Proposed Bala Falls Generating Station

The proponent has not provided enough information to proceed with anything

■ Completion bond

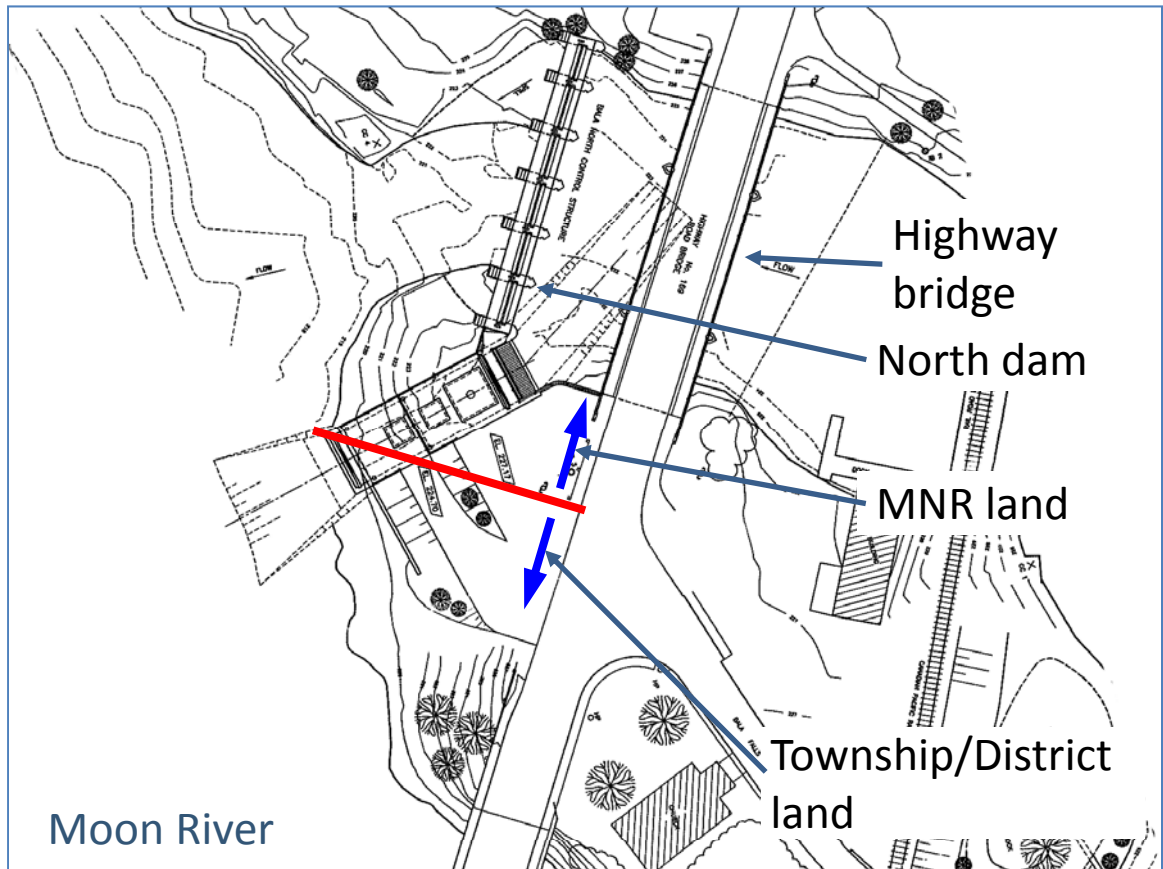
- How would public be protected from paying for site restoration
 - ▶ 300' of rocks dumped in river for coffer dam
 - ▶ 40'-deep trench across highway

Proponent has only offered to cover small items
such as the interconnection to the electrical grid

Option 1, Revision 2

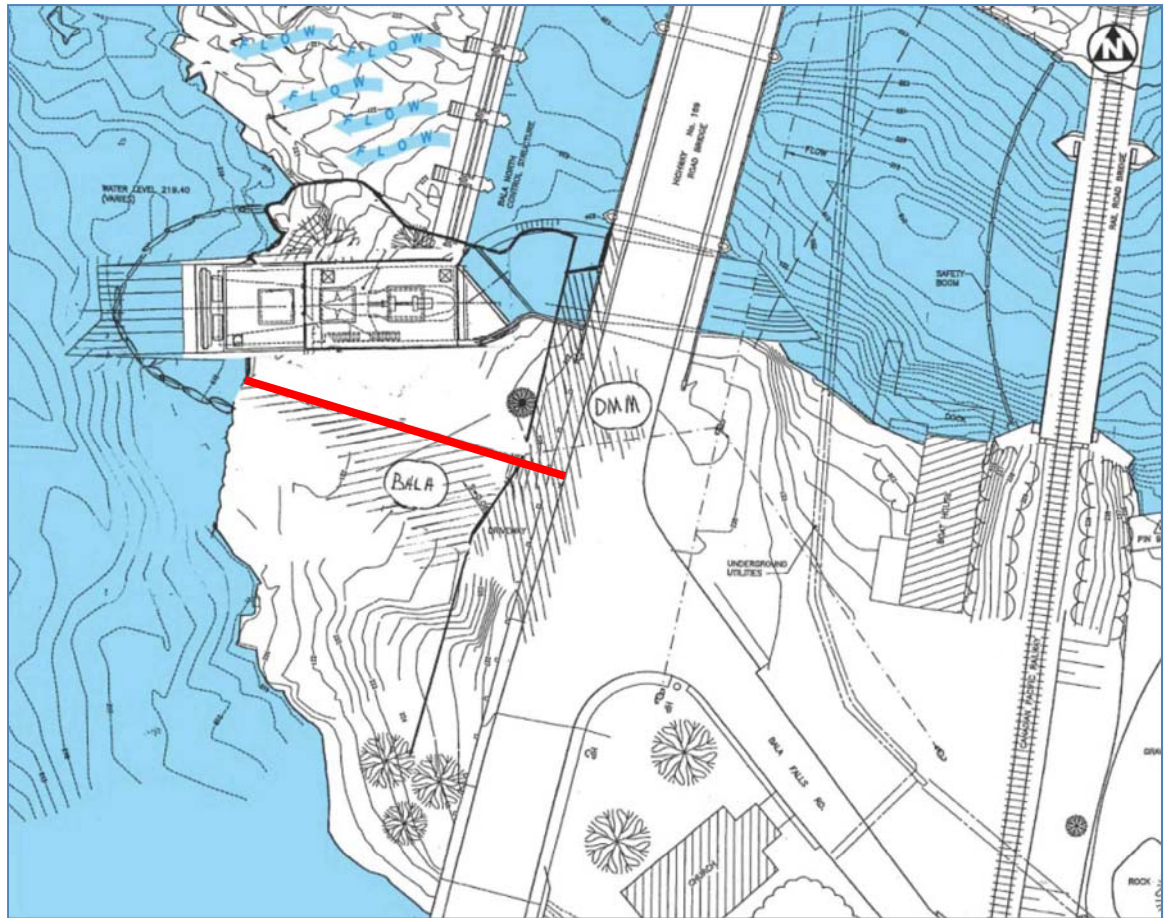
- October 2009 Environmental Screening Report, Appendix A, *“proposed as part of the site release program application”*
- Again, not all on crown land

Option 1, Revision 4

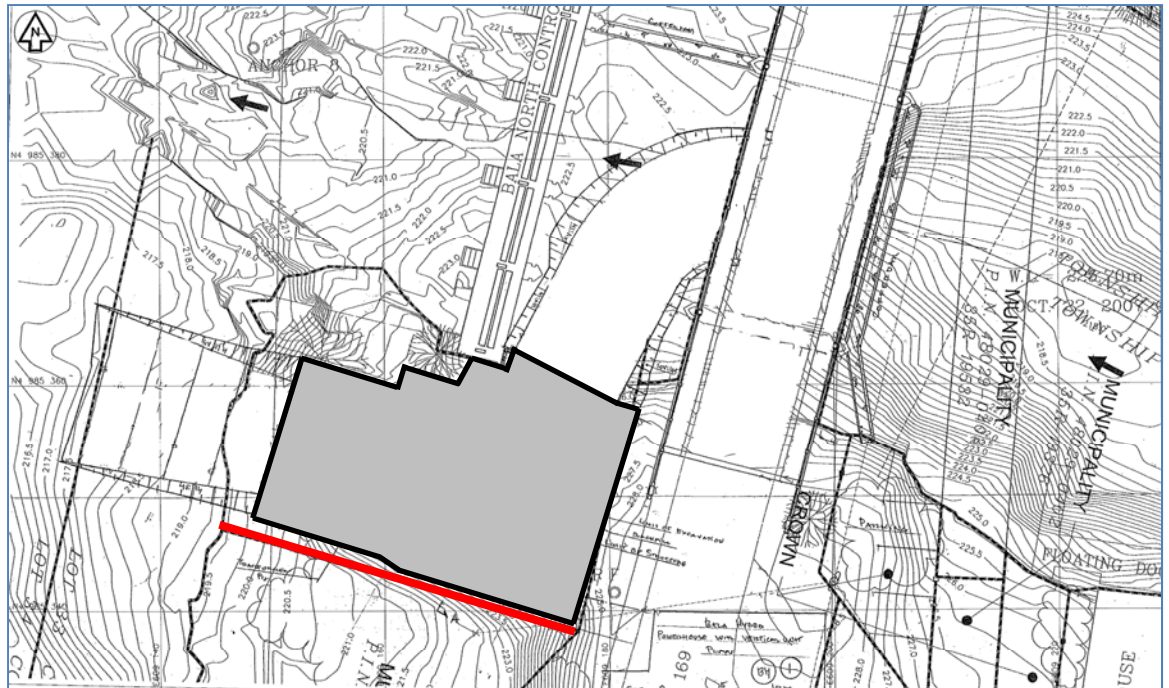
- September, 2010
- All on crown land
- Vertical turbine

***Are any of
these
Option 1***

Option 1: Safety issues

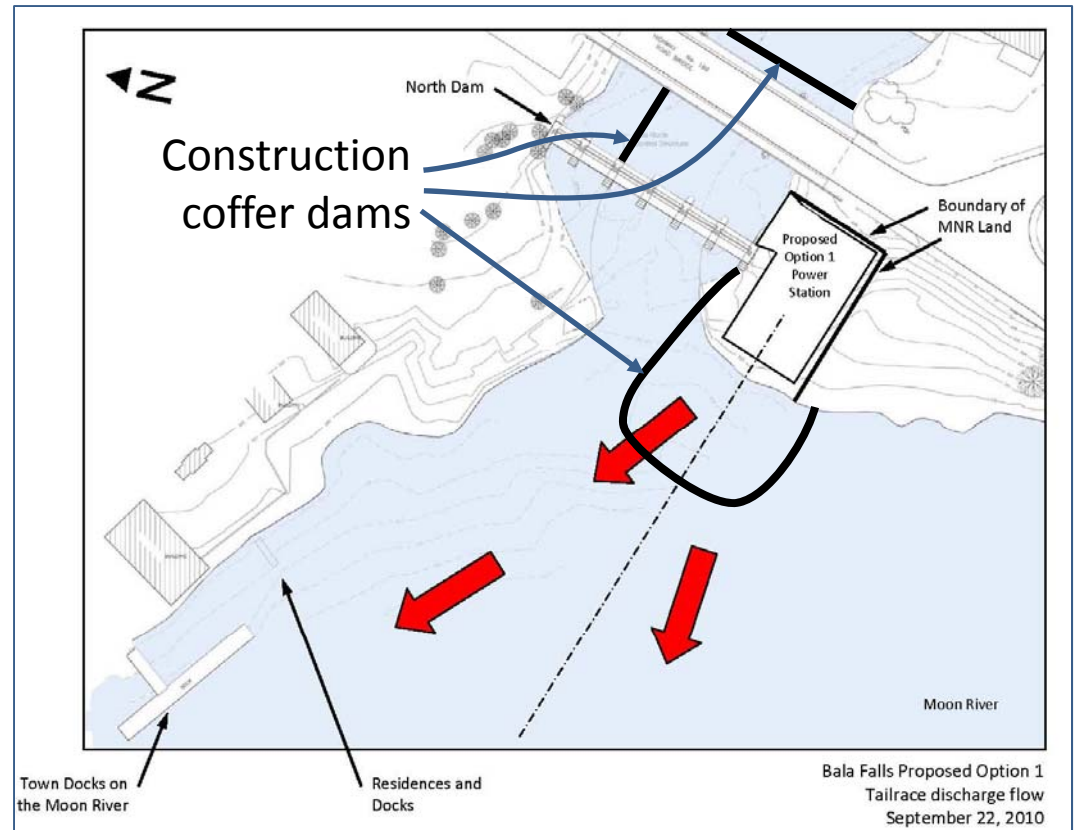
- Tailrace flow
 - Environmental Screening Report: *“The tailrace of the powerhouse would be located in close proximity to the falls which could cause **safety issues** ...”*
 - Tailrace flow would also affect **use of Town Docks** on the Moon River
- What if the **dam was damaged** by blasting
